UNITED STATES PATENT AND TRADEMARK OFFICE

| APPLICATION NO. | FILING DATE | FIRST NAMED INVENTOR | ATTORNEY DOCKET NO. | CONFIRMATION NO. |
|-----------------|-------------|----------------------|---------------------|------------------|
| 10/023,474 | 12/17/2001 | Luke K. Liang | | 3629 |

Office Action Summary

DETAILED ACTION

Attachment #1

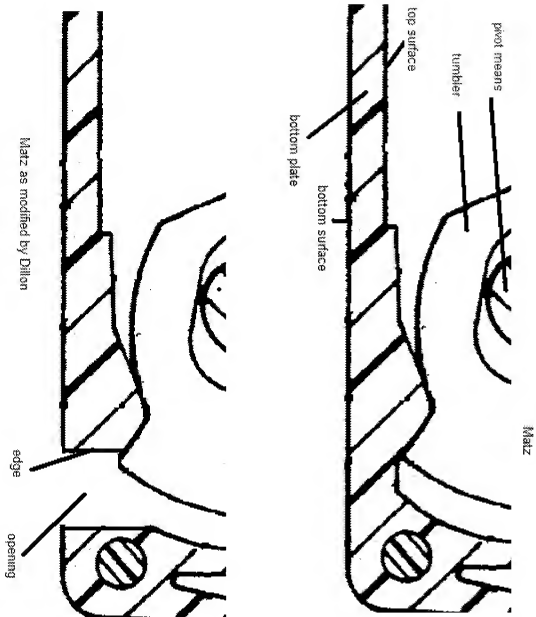
The tumbler further comprises a first pivot member that is capable of being in contact with the pivot means (38) when the tumbler is in the extended position (Figure 6, the opening contact the surface of 38), and a second pivot member that contact the bottom surface of the housing to prevent over travel of the tumbler (see attachment #1).
